# Service Bulletin

Bulletin No.: 18-NA-246

**Subject:** Malfunction Indicator Lamp (MIL) Illuminated - DTC P0172 Set

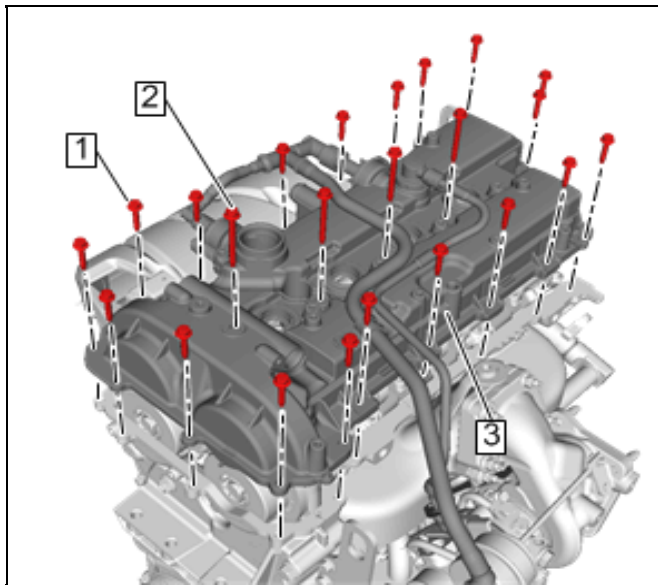
**Note:** The graphic above compares the old style primary PCV valve (A) to the revised PCV valve (B).

1. Remove the camshaft cover (3). Refer to *Camshaft Cover Replacement* in SI.
2. Remove the PCV valve from the cover.

3. Apply a light coating of oil to the revised PCV valve O-ring.

4. Using hand pressure, install the PCV valve into the cover until seated into bore.
5. Install the camshaft cover.
